## Design Revisions in Response to Previous CHAPC/UDP/Community Input

105 Keefer Street + 544 Columbia Street

#### RE: Development Permit Application 105 Keefer Street + 544 Columbia Street Vancouver BC

## UDP Response

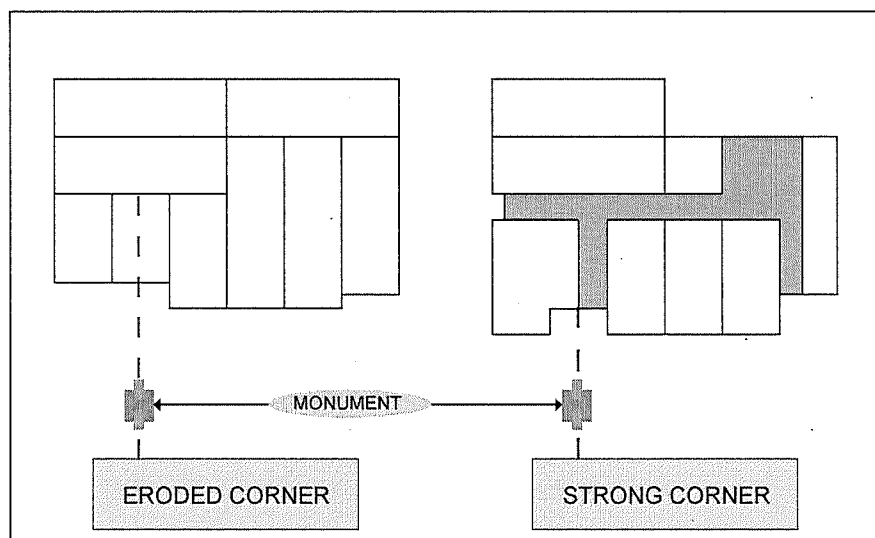
UDP COMMENT	11 JAN 2017 UDP MINUTES SUMMARY AND RESPONSE
1. DESIGN DEVELOPMENT TO GET MORE DAYLIGHT INTO THE BREEZEWAY	Levels 10-12 removed , greatly increasing light access down to levels 7-9 and below.
2. CONSIDER SIMPLIFYING SOME OF THE BUILDING ELEMENTS, PARTICULARLY ON THE ROOFTOP	Roofscape simplified with removal of L10-12. Elevator rooftop access to upper roof Amenity expressed, plus hatches to roof from L9.
3. USE COLOUR TO ACTIVATE THE BUILDING MORE	Colour introduced to elevator/stair core to tie building colour composition together, and to orient visitors to location of Residential Lobby and stairs. Vertical Neon sign to add further colour/light animation
4. ENGAGE AN ART CONSULTANT TO ENHANCE BUILDING	Art will be provided as an owner initiative

## CHAPC Response

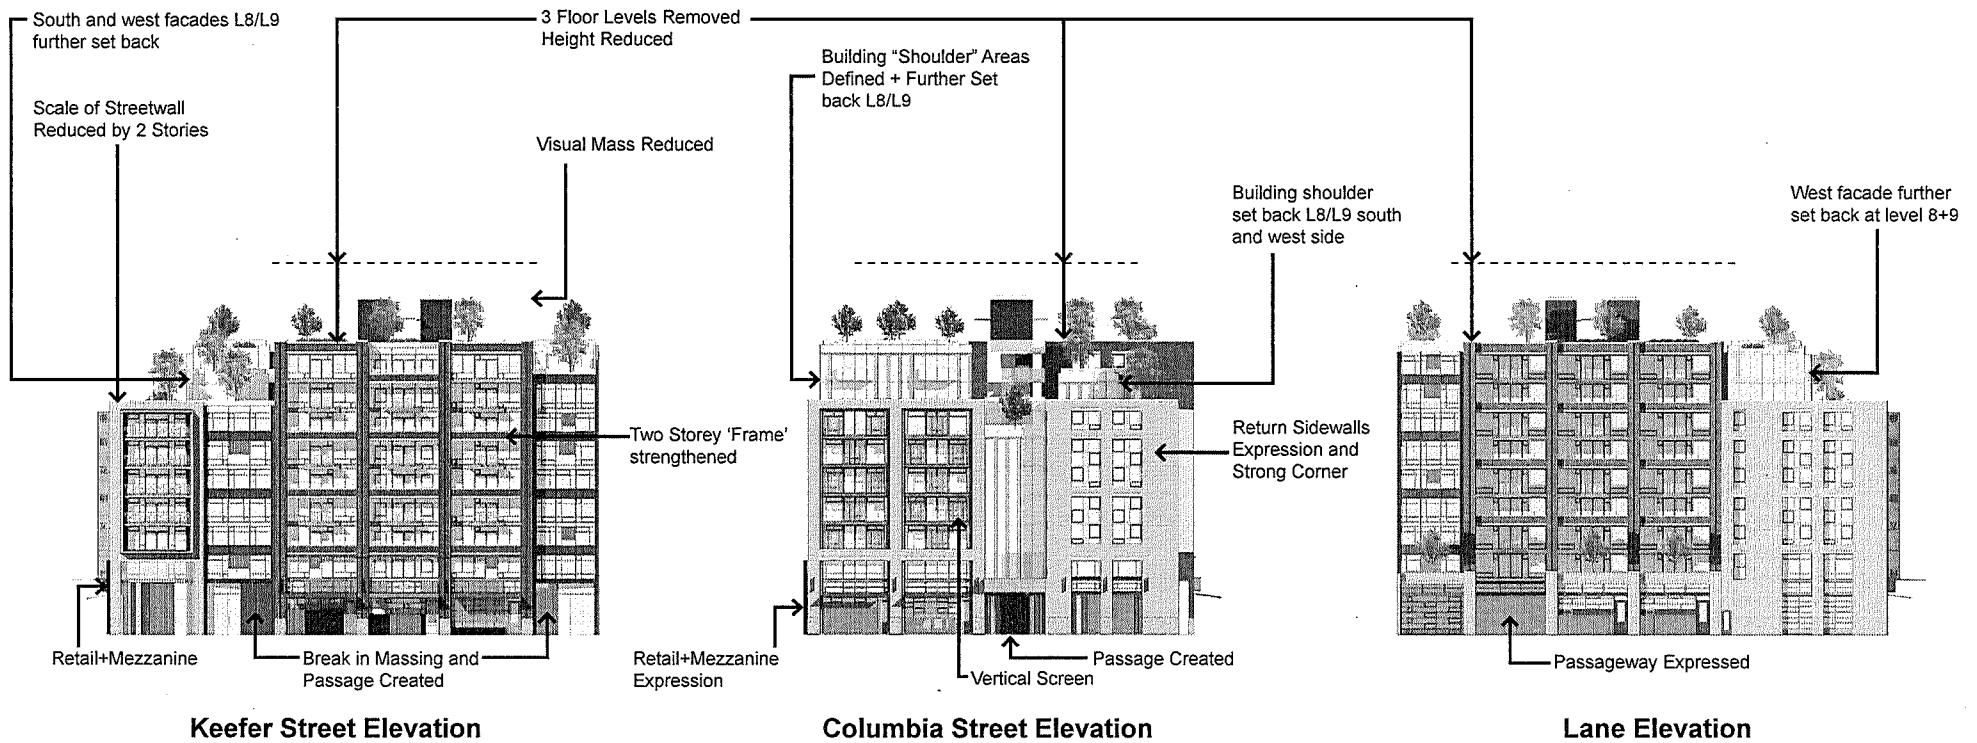
CHAPC COMMENT	APPLICANT RESPONSE
REDUCE SCALE + HEIGHT + FSR	The project has been reduced in FSR area from 128,648 sf to 118,731 sf. The project scale has been broken down into three distinct building elements and reduced significantly in height by three stories overall.
IMPROVE LIVABILITY + IMPROVE QUANTITY AND TYPE OF AMENITY SPACE	Residential amenities substantial additional roof terrace area added above L7. Community Cultural Space at L1.
RECOGNIZE SENSITIVITY OF SITE RELATIVE TO THE HERITAGE AREA, MEMORIAL SQUARE, DR. SUN YAT SEN GARDEN, AND THE NEARBY MUSEUM	In response to the site context, the project has been lowered and reduced by 3 floor levels. It has been revised and broken down in scale into three distinct volumes. The following strategies respond to specific site sensitivities:
<ul style="list-style-type: none"> <li>HERITAGE AREA</li> </ul>	The Building mass scales down towards the lower scale of the Pender Street heritage buildings (see Columbia Street elevation) with additional roof substantial setbacks from the south and west facades at levels 8+9.

<ul style="list-style-type: none"> <li>MEMORIAL SQUARE</li> </ul>	The project ground floor is set back 52' from the Monument, and facilitates flow into the Square to and from Columbia via the new passageways.
<ul style="list-style-type: none"> <li>DR. SUN YAT SEN GARDEN</li> </ul>	The building height has been lowered, and reduced by 3 floor levels. The building is not visible above the wall of the Scholars Retreat, consistent with Policy, and levels 8+9 have been substantially set back from the south and west facades.
<ul style="list-style-type: none"> <li>MUSEUM</li> </ul>	The project height has been lowered, and reduced by 3 floor levels. The site of the former Chinatown Theatre on Columbia Street façade is animated by patterned perforated metal screens, responding to the pattern screens along the Museum facade.

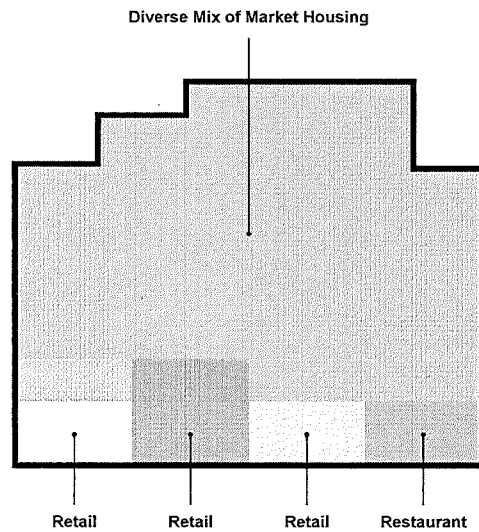
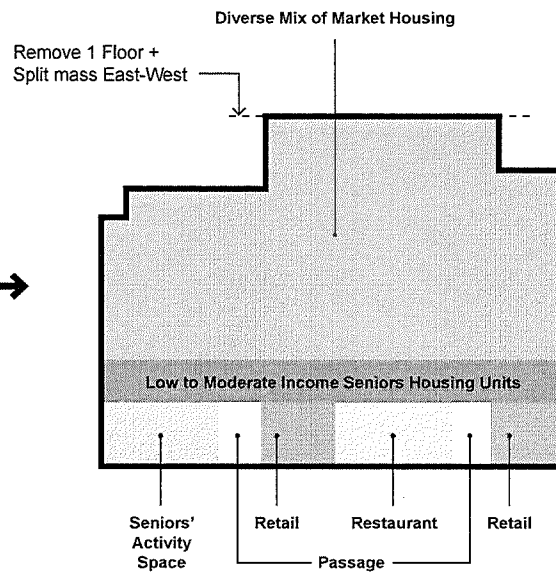
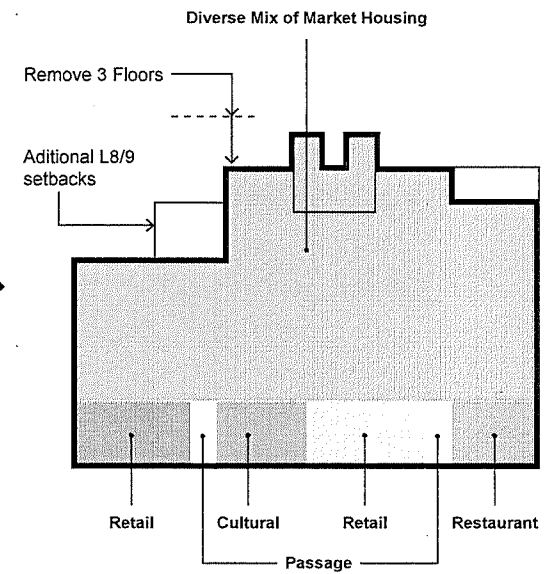
Original Rezoning Proposal 2014

Revised Rezoning Proposal Dec. 2016

Development Permit Proposal 2017
